**Correspondence Between  
Staff and Applicant**

RE: 3-ZN-2015  
Southwest Corner of Ranch Gate & 128th Street

The Planning & Development Services Division has completed the review of the above referenced development application submitted on 2/2/2015. The following **1<sup>st</sup> Review Comments** represent the review performed on by our team, and is intended to provide you with guidance for compliance with city codes, policies, and guidelines related to this application.

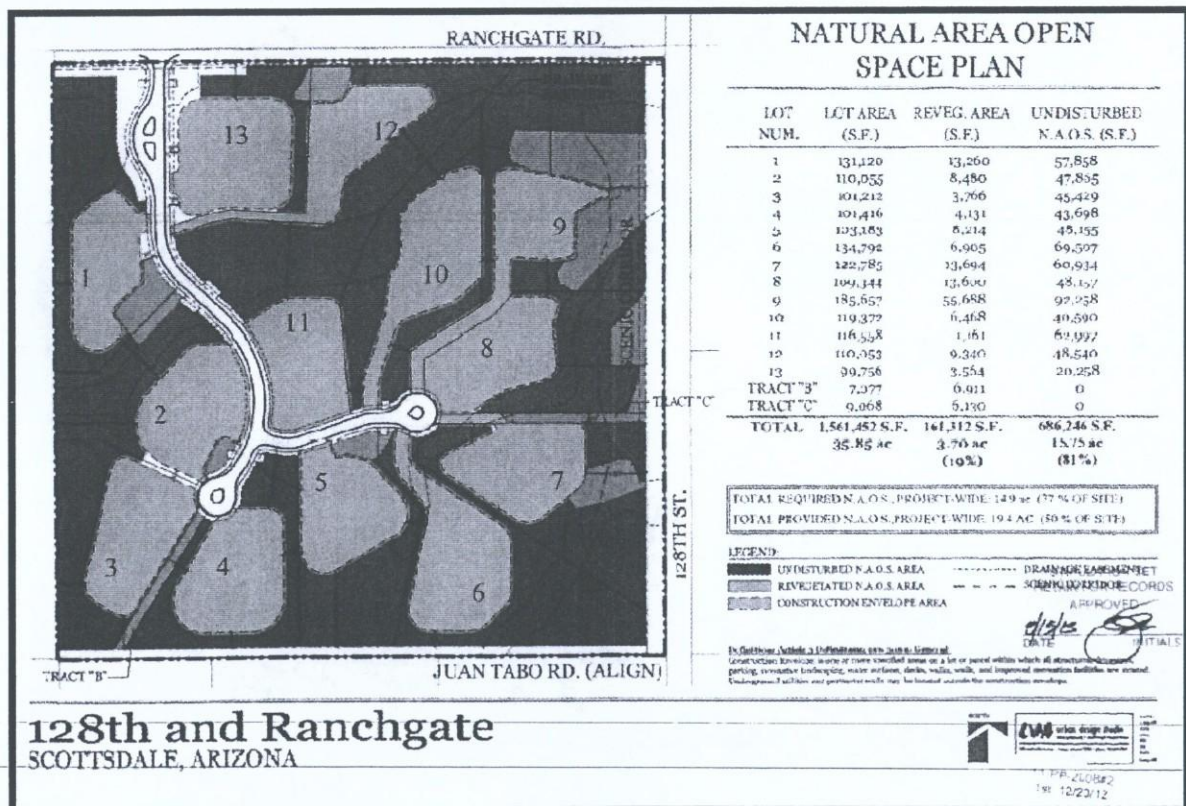
- q. Please respond to Goal #2 of the Open Space and Recreation Element – specifically bullet 11.
- r. Please respond to the Preservation and Environmental Planning Element, specifically Goals 2, 3, and 9 along with the associated approaches.
- s. With the next submittal, please submit a revised Project Narrative responding to the Community Mobility Element, goals and applicable for approaches #7, #9, and #10.
3. Upon resubmittal please update the graphics provided with the 1st submittal narrative as noted below:
- a. The Dynamite Foothills Character Area inset map on page 1 looks like it shows the incorrect location of the subject site. Please submit a full-page map with the next submittal, noting the correct location of the subject site.
